The following letter and revised drawings respond to your review and comments for 53<sup>rd</sup> and Tennyson Row project at 4301 W. 53<sup>rd</sup> Ave, Log number PRC2020-00005. Responses are listed below in **red**. Please call or email if you have any questions or require additional information.

# 53RD AND TENNYSON ROW - LANDSCAPE PLAN

# Comment Response

The following letter responds to your plan review and comments for the project at **4301 W. 53<sup>rd</sup> Avenue, Denver, CO 80212**, Application #PRC2020-00005 and EGR2020-00007. Responses are listed below in **red**. Please call or email if you have any questions or require additional information.

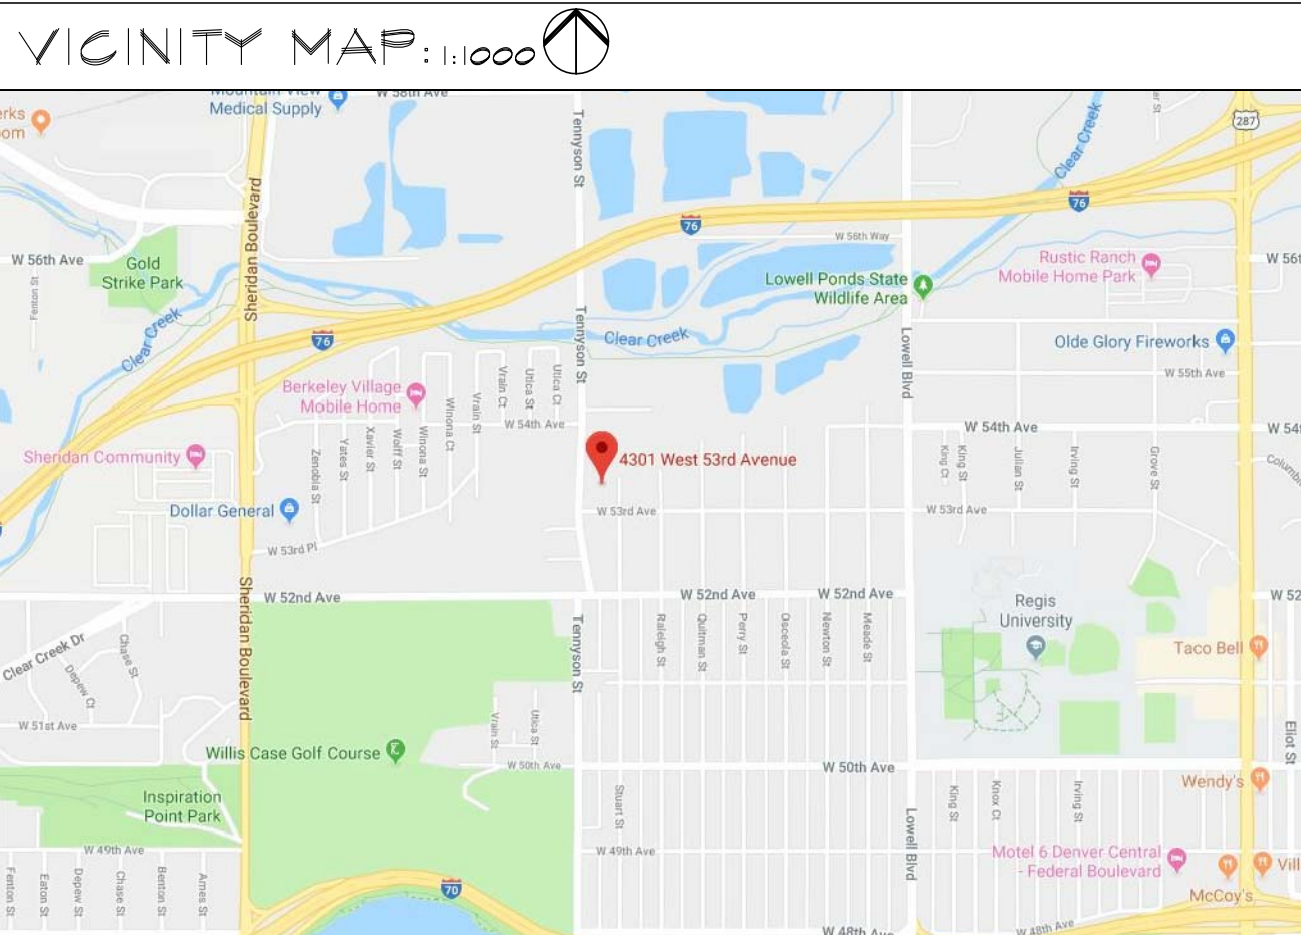
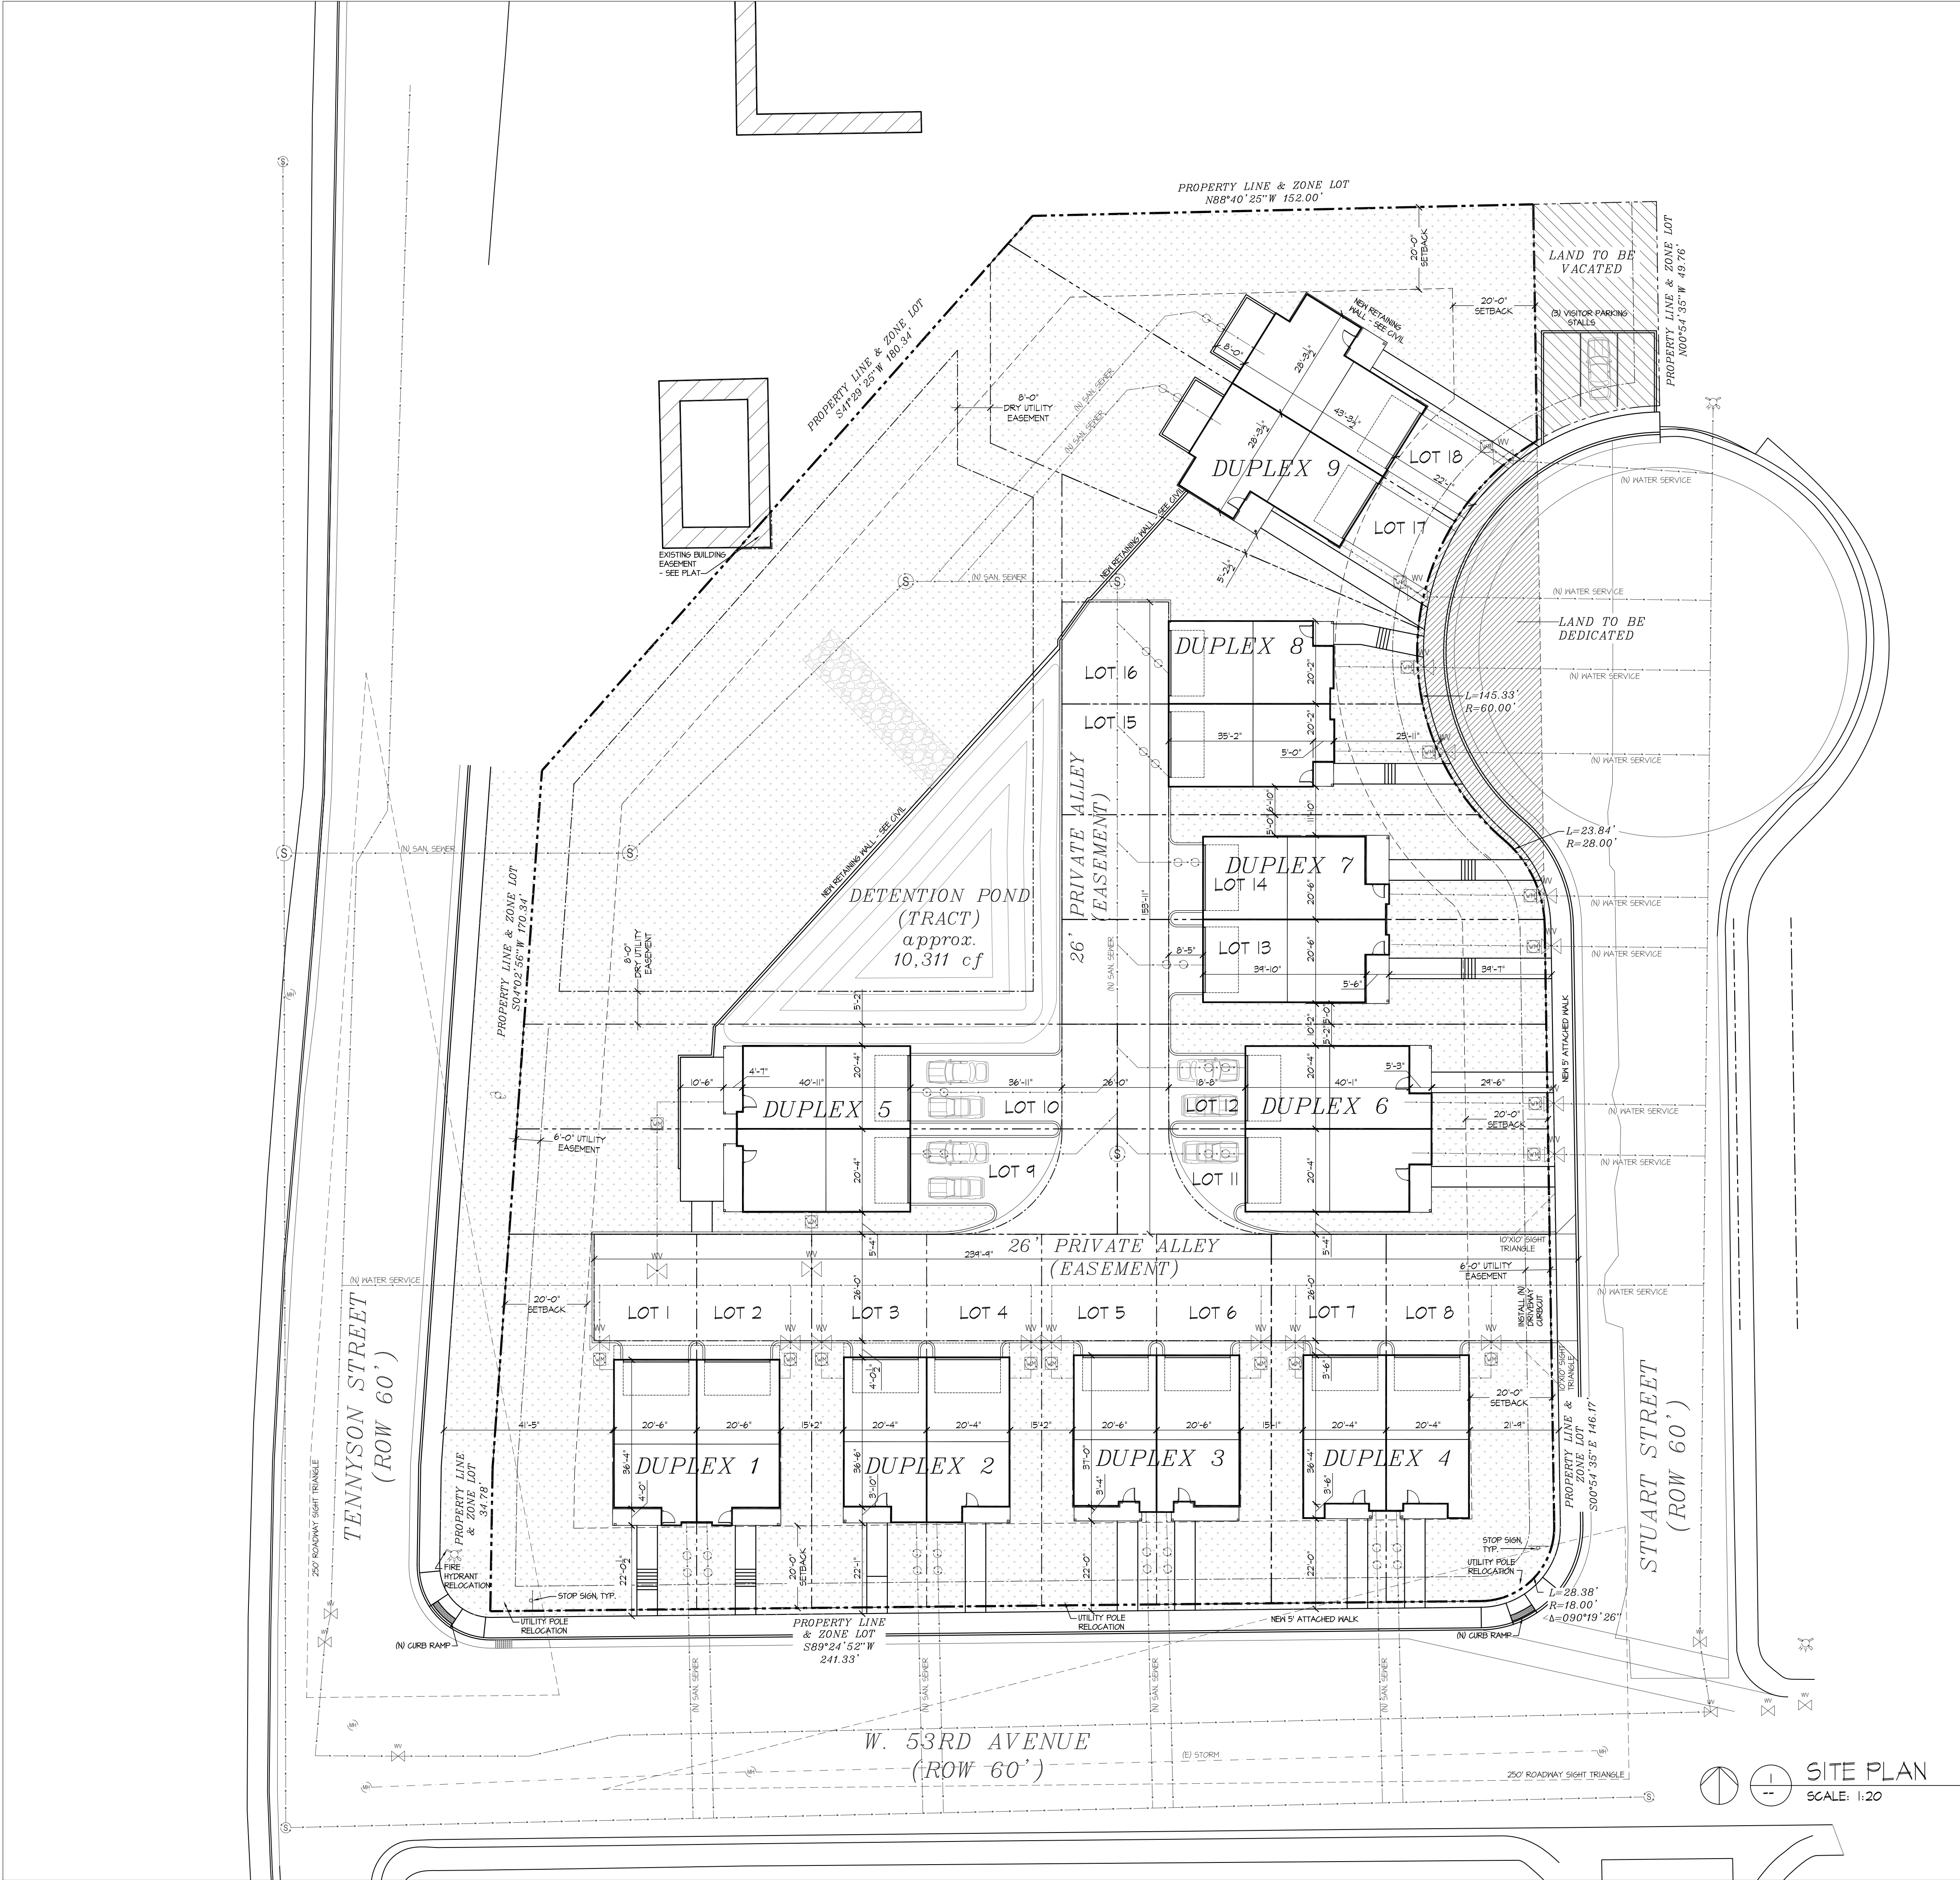
- i. Site Plan does not indicate any common trash areas, assumed individual pickup. How would Duplex 5 be served?

*Trash will be individual pickup. The trash truck may drive in the private alley to pick up trash carts.*
